DESIGN & CONSTRUCTION MANUAL DESIGN CRITERIA MODIFICATION REQUEST

PROJECT NAME: The Village at Discovery Park Zone 1 – Public Sanitary Sewer Plans

PERMIT NUMBER: PL2023145 (Project #)

SHEET
EXH-01

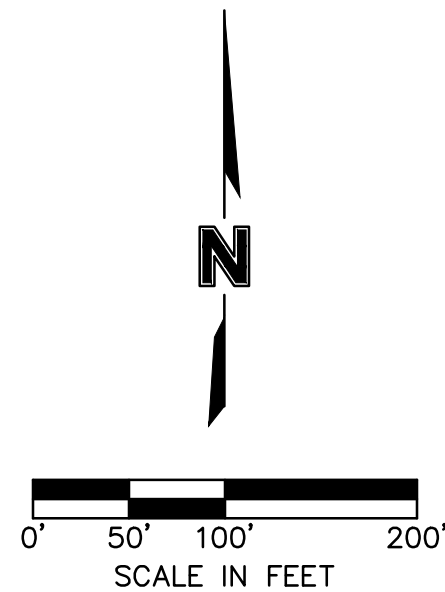
A modification to Section 6501.E.3.a is requested to allow an increase of maximum depth of sanitary sewers and manholes from 20 ft to 23.04 ft. Modification will apply to EX. SANITARY LINE Z (existing 12" sewer main that's partially relocated) shown on sheets C653-C655 of referenced plans.

The sewer main in question will be running along the top of embankment of proposed wet permanent detention basin. The basin geometry and grading are dictated by storm water detention and water quality requirements. Also, since the sewer main is existing, it's flow invert elevations are fixed at upstream and downstream points. Following measures were taken to minimize the depth of the sewer:

a) proposed pipe run from structure NEW MH 16-008 to SAN Z2 was flattened from 0.67% to 0.40%;

b) proposed pipe run from structure SAN Z2 to SAN Z1 was flattened from 6.84% to 3.67% and straddle blocks added to pipe run from SAN Z1 to EX MH 16-006, which brought portions of EX. SANITARY LINE Z under 20 ft deep;

c) proposed pipe run from structure SAN A1 to NEW MH 16-010 was flattened from 5.48% to 1.10% and outside drop was added at NEW MH 16-010, which brought LINE A under 20 ft deep;

Although all the efforts were made to keep the relocated and existing sewer main as shallow as possible, the basin grading and fixed flow invert elevations of the sewer lead to a need in design modification request for portions of EX. SANITARY LINE Z and SANITARY LINE C. Refer to exhibit attached for extents of waiver request and max. depth at each pipe runs and manholes.
